**Submission to the HumeLink, Contingent Project Application – Stage 2, HumeLink Alliance Inc.,  
April 3, 2024**

**Figure 2: Number of residences impacted by HumeLink in the Green Hills and Yass regions**

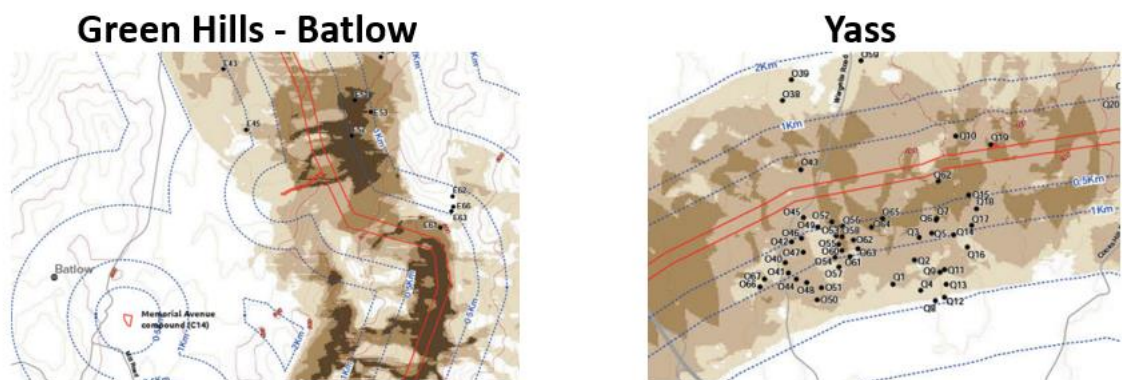
Submissions to the EIS closed October 10, 2023, and yet Transgrid is still to contact the 4,322 indirectly impacted landowners. Members of the community have been doorknocking Yass residents shown in map below in Figure 2. Not one had been contacted directly by Transgrid, and most knew nothing about the HumeLink project, which will devalue their properties by hundreds of thousands of dollars. This is a major failure of Transgrid’s consultation.

With the Green Hills State Forest refinement announced in November 2023, Transgrid are improving the visual amenity for 10 landowners, whereas in the Yass region, no attempt has been made to reduce the impacts on around 50 residents (see Figure 2).

Figure 1(a): Representative Diagram of a Transposition

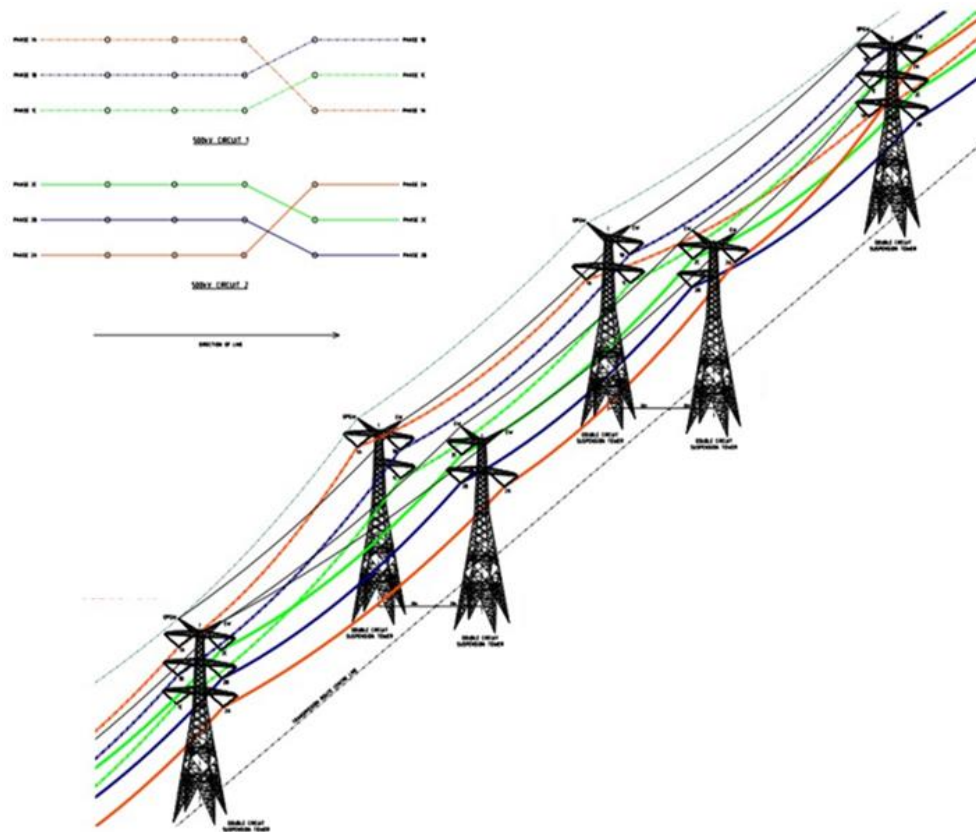
As CCG members, the EIS had us presented with new information that we had never been provided before. As a very recent example, I innocently asked what appears to have been a loaded question, in relation to the EIS stating in some places there would be 110-130m easements. Where would these be? Would this occur on our property? What I did not bank on was these larger easements are where Transpositions occur. As you can see by Figure 1(a) a Transposition is an even greater burden, and industrial impact that has until now been hidden, and quite possibly would have stayed that way until the question was asked. Seven Transpositions will be placed along the 365 km route. At seven locations landowners will be getting two sets of towers, two transmission lines, on their properties. This admission is the last straw and it is certain that this further warrants the need to underground Humelink.

The explanation I was given for the use of Transpositions is ... 'a process of changing the order of conductors along the towers to balance transmission losses over the length of the line'. Interestingly, a strategy to manage the 'losses' that plague overhead AC infrastructure, when in fact experts in HVDC underground have stated all along, and have well documented that undergrounding via HVDC substantially minimises the losses in comparison to overhead. So underground it!

**Figure 2(a): GHD solution, option 2A: 2 x 2.1m trench, 3m separation, total width 7.2m**

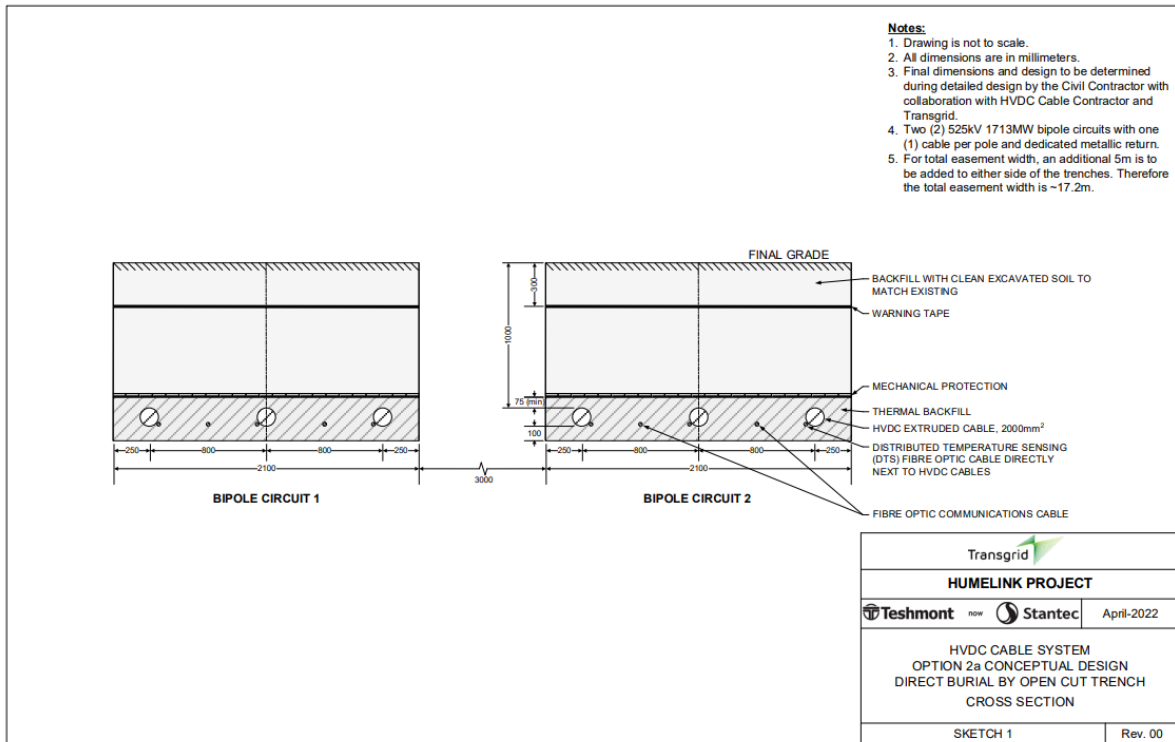
Let's compare the facts GHD has given to Transgrid, shall we. The GHD study has the trench sizes of Humelink at 2.1m each, with some examples even smaller (See Figures 2(a) and (b)). But Transgrid stated under oath in the inquiry that a 50m trench will be required.

**Figure 5: Amplitude Review modified option 2A, 2 x 1.5m trench, 1m separation, total width 4m**

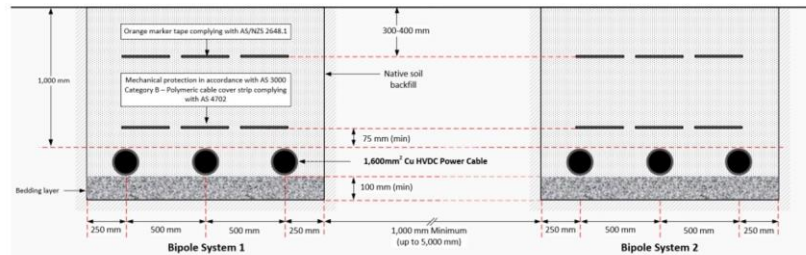
Murraylink is a 180km HVDC underground system that has won Environmental Awards, and is known for managing to only remove two trees in its wake. Transgrid consistently suggests that undergrounding is more environmentally damaging, yet we are comparing a 70m easement overhead, to a probable 12m easement for undergrounding. As per the Amplitude Review, we are talking 2 x 1.5m wide trenches, to a depth of 1.25m (see Figure 5 below), in comparison to the clear felling 70m wide easements, 50m X 70m crane pads, massive cement tower pads, and footings buried in concrete to a depth of up to 25m, and towers up to 80m tall - a visual and physical impediment to the environment for 80 years.
